IEEE 802.3cg
PLCA Burst mode
November 7th, 2018

Figure 148-4—PLCA Control state diagram (continued)

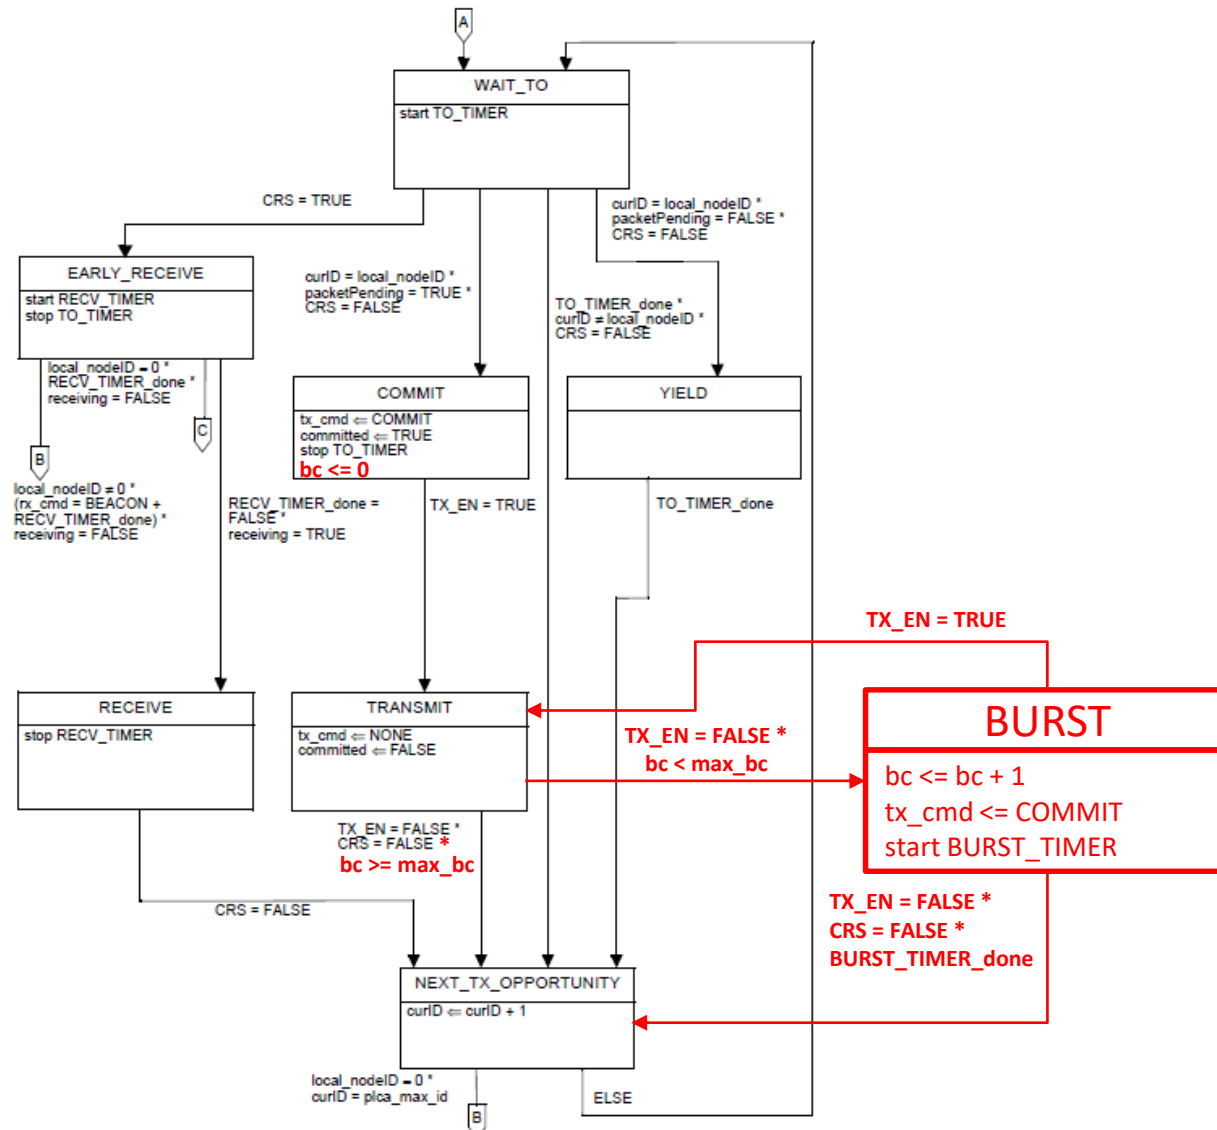
Changes to State Diagrams
